Hi-Fi Products  
Service Bulletin

**Model:** STR-GX57ES/GX67ES

**No. 233**

**Subject:** Unit Goes Into Protection With High Volume  
On Rear Amp

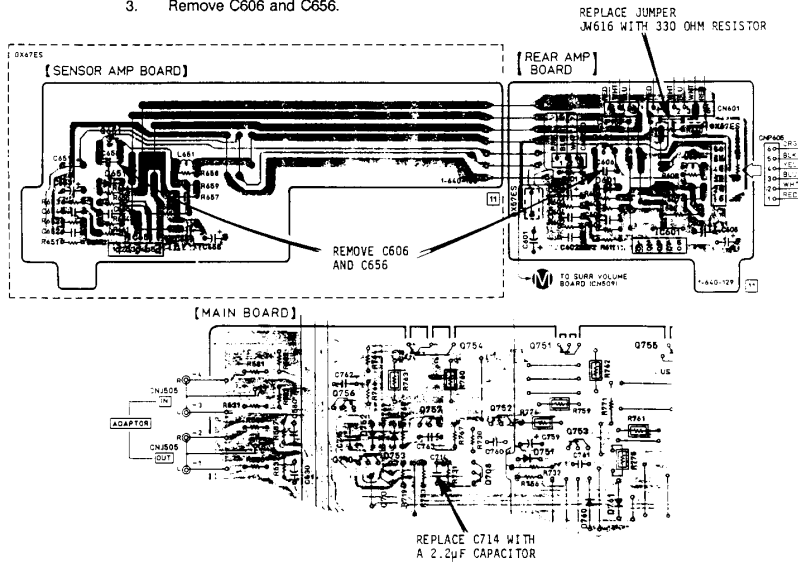
**Symptom:**  
(12) Setting the rear amp volume too high causes the protection circuit to activate.

- Solution:**
1. Replace C714 from a 0.1 $\mu$ F to a 2.2 $\mu$ F.
  2. Replace jumper JW616 with a 330K ohms resistor.

REF. NO.	DESCRIPTION	PART NUMBER	
		ORIGINAL	NEW
C714	0.1 $\mu$ F	2.2 $\mu$ F	1-124-925-11
JW 616	JUMPER	RESISTOR, 330K ohms	1-246-533-00

3. Remove C606 and C656.
